RESPONSES TO  
NRC QUESTION  
ON THE  
DUANE ARNOLD ENERGY CENTER  
PUAR

PREPARED BY  
NUTECH ENGINEERS, INC.  
SAN JOSE, CALIFORNIA

PREPARED FOR  
IOWA ELECTRIC LIGHT AND POWER CO.

NRC QUESTION ON DUANE ARNOLD ENERGY CENTER

Figure 6 - 2"φ

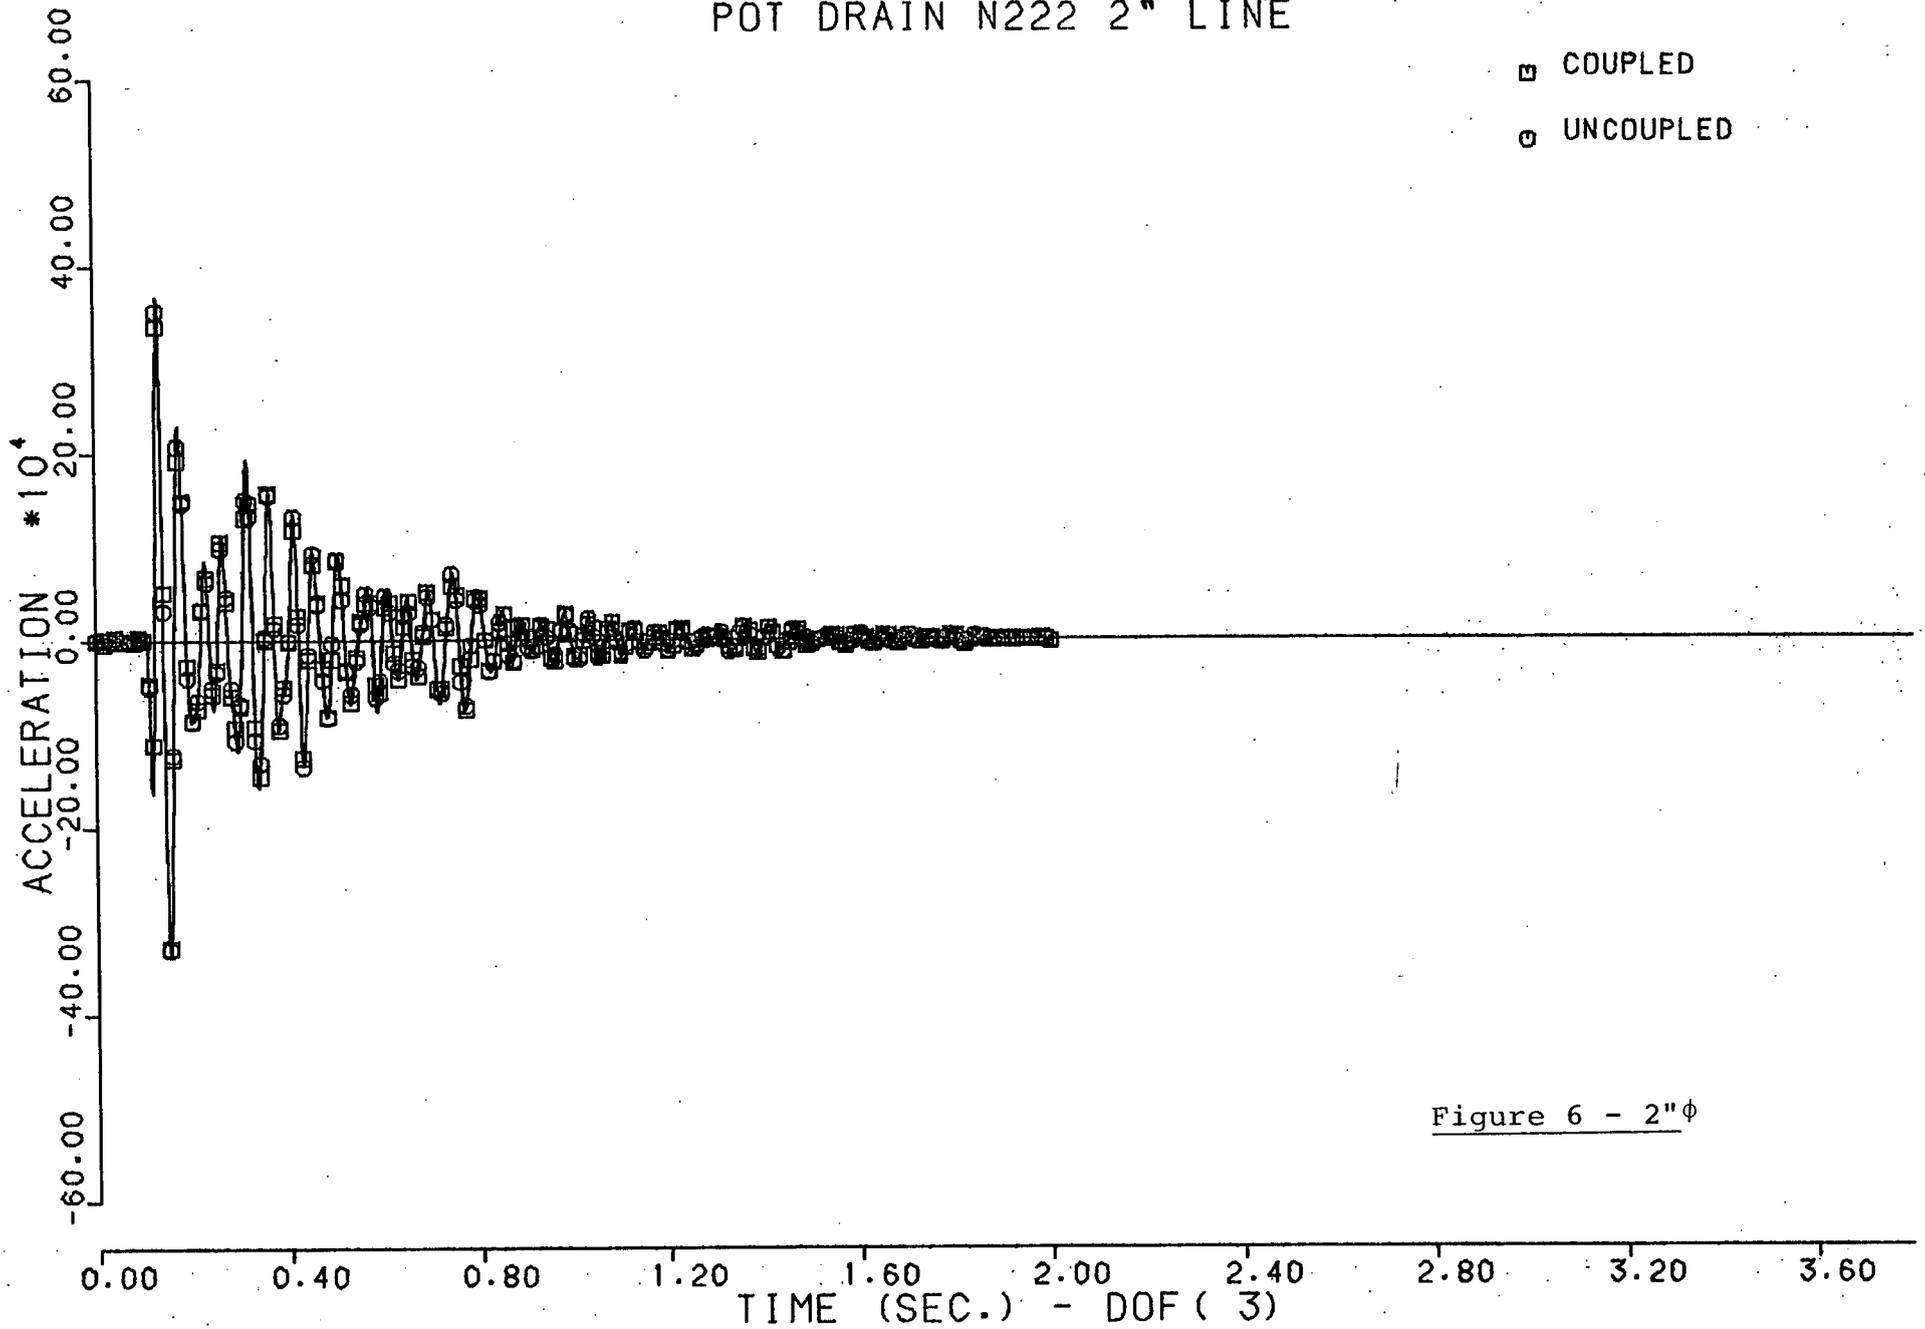
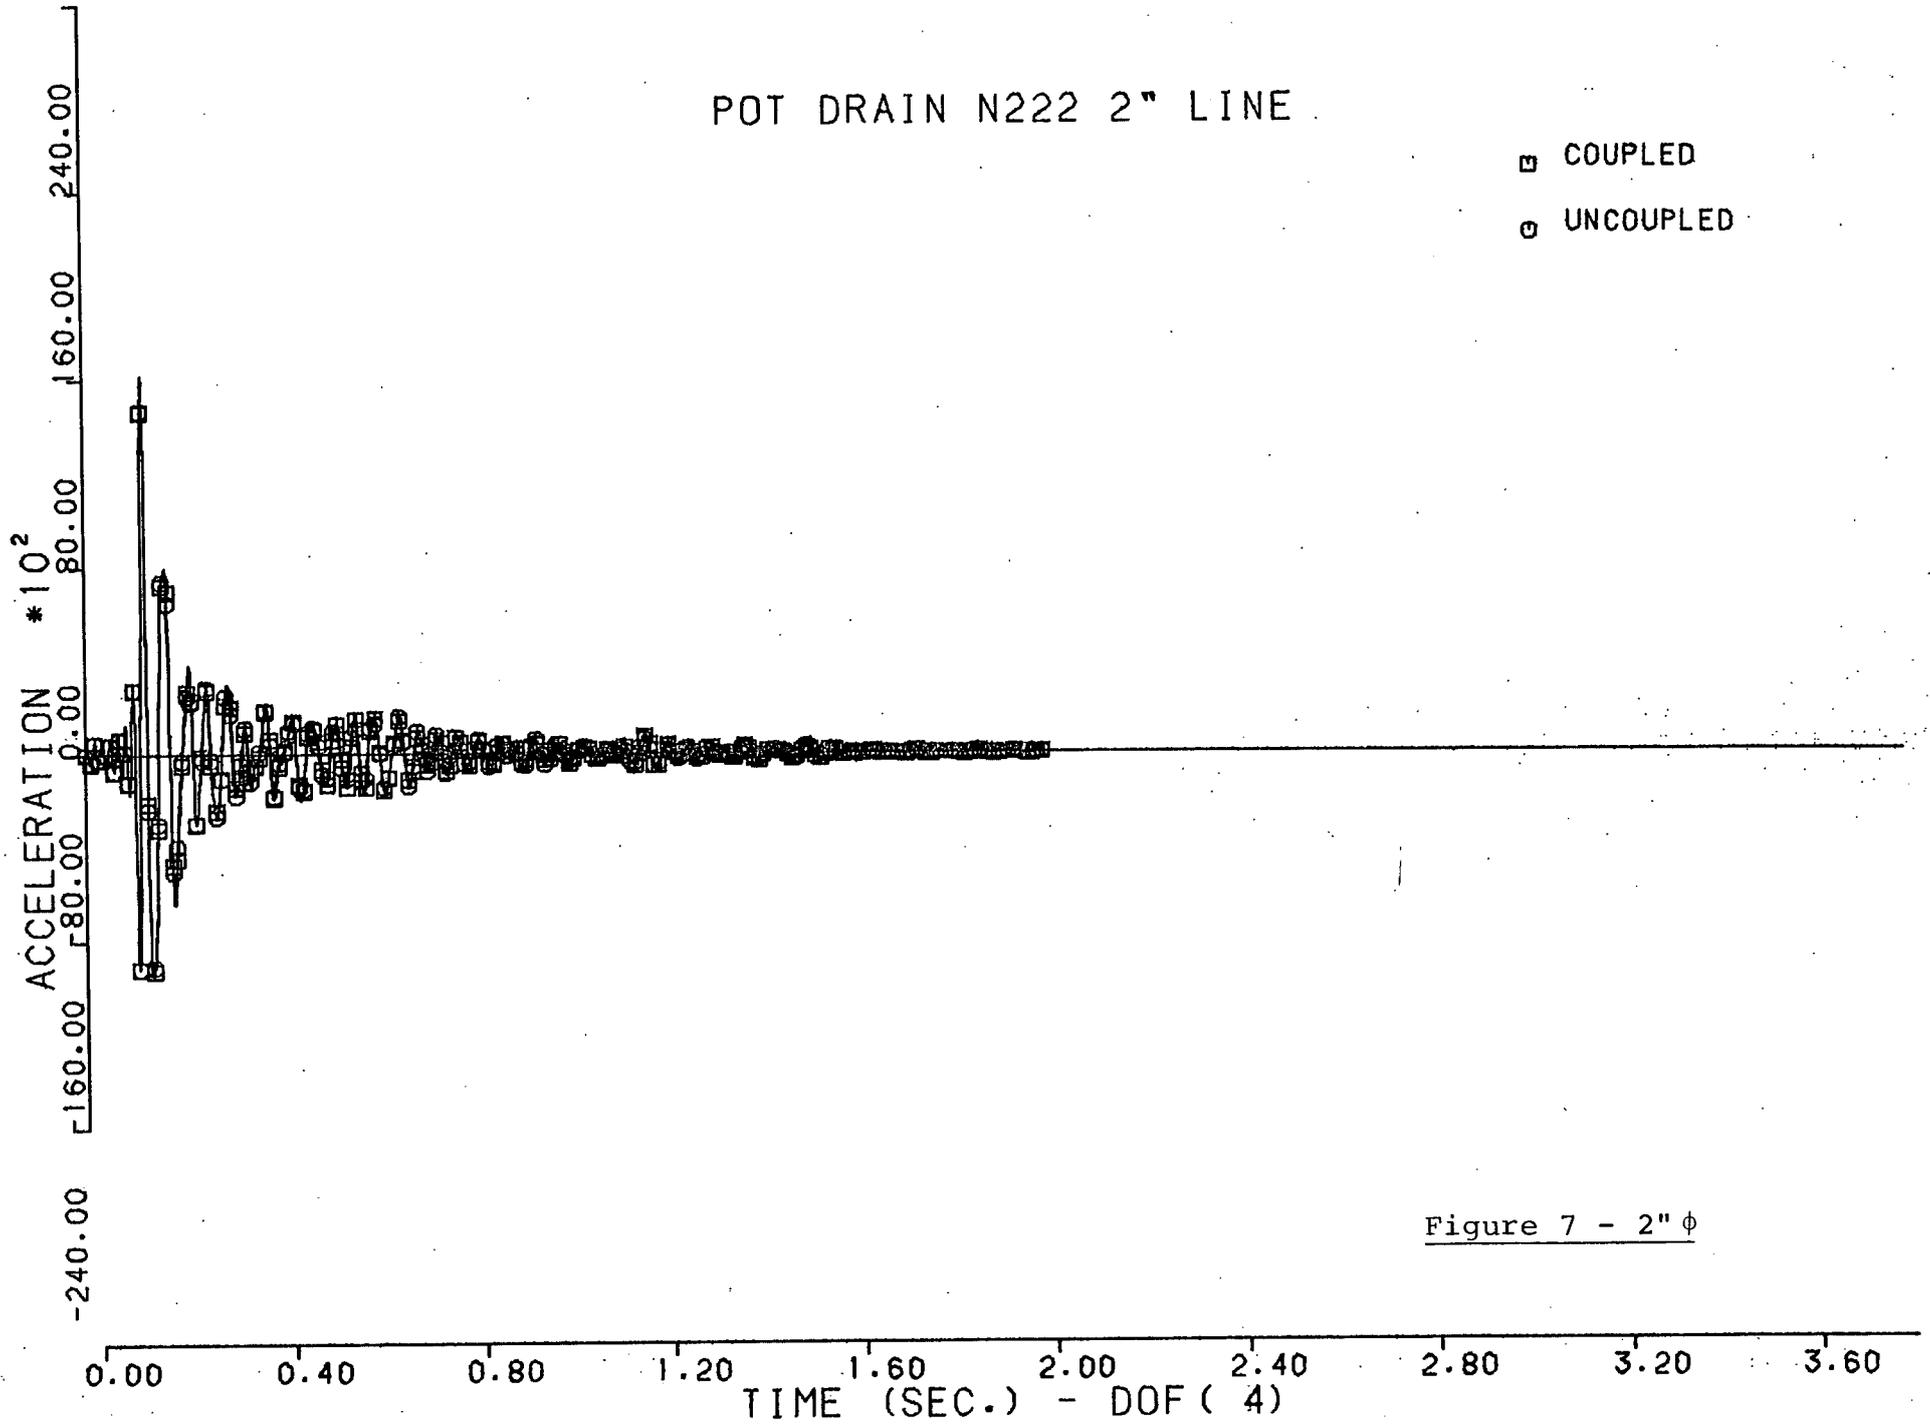
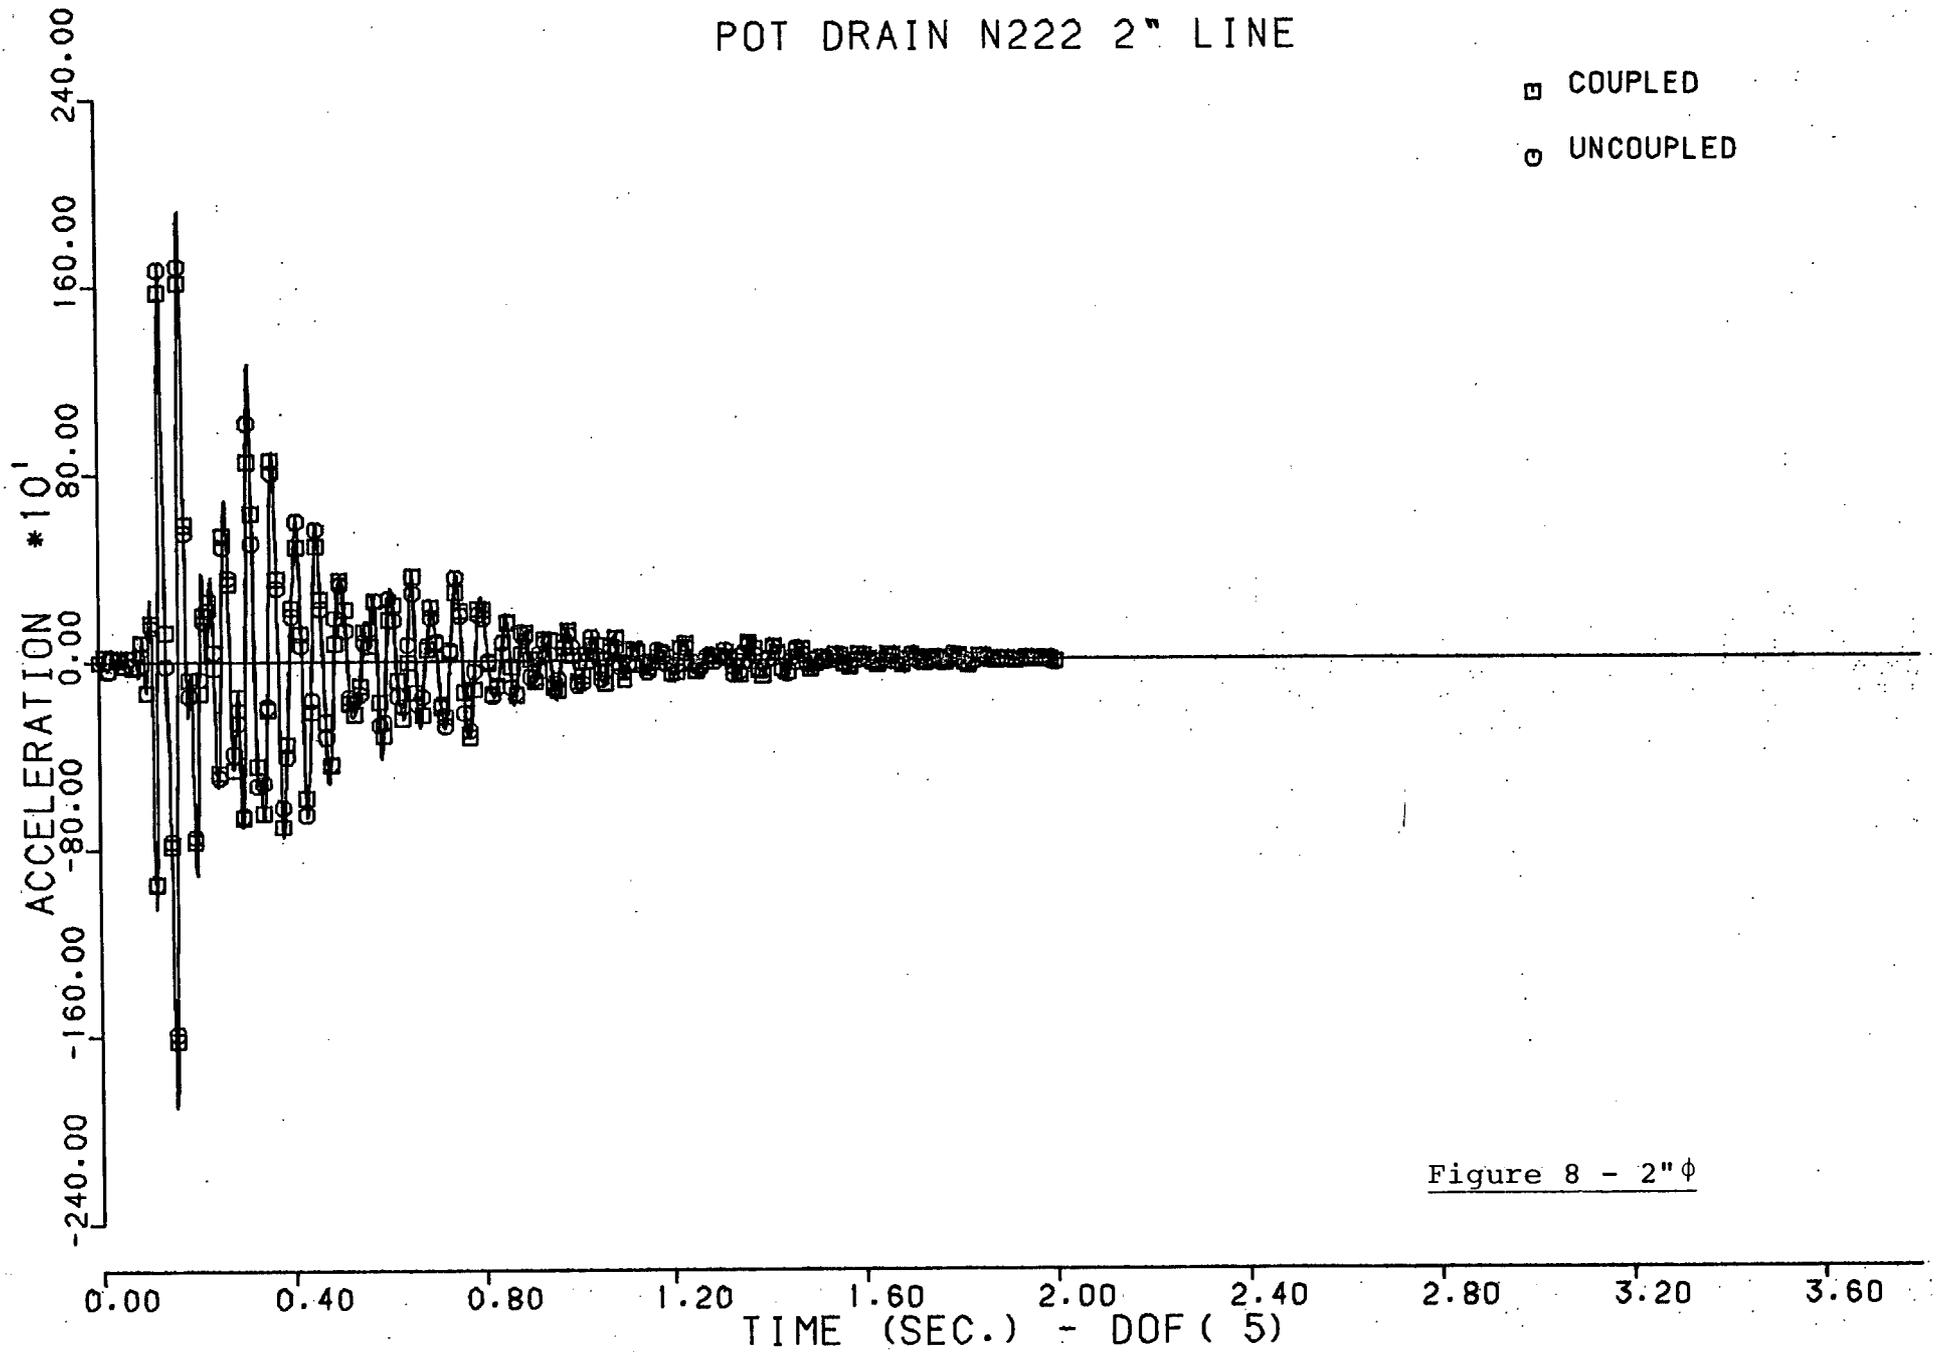
ITEM 3a: Provide the theoretical background in support of Section 2 of the report, and describe how the Section 6 guidelines (i.e., cut-off frequency and equations 2.27 and 2.28) have been used in the analysis.

To illustrate the effect of pipe size on coupling, four typical piping systems were examined and the coupled and uncoupled time histories plotted together. These time histories include both the smallest (2") and larger (20") systems analyzed. Listed below are the figure numbers and the corresponding line size.

Figure 4-8	2" diameter
9-13	4" diameter
14-18	6" diameter
19-21	20" diameter

These plots confirm the expected variation of coupling benefit with pipe size.
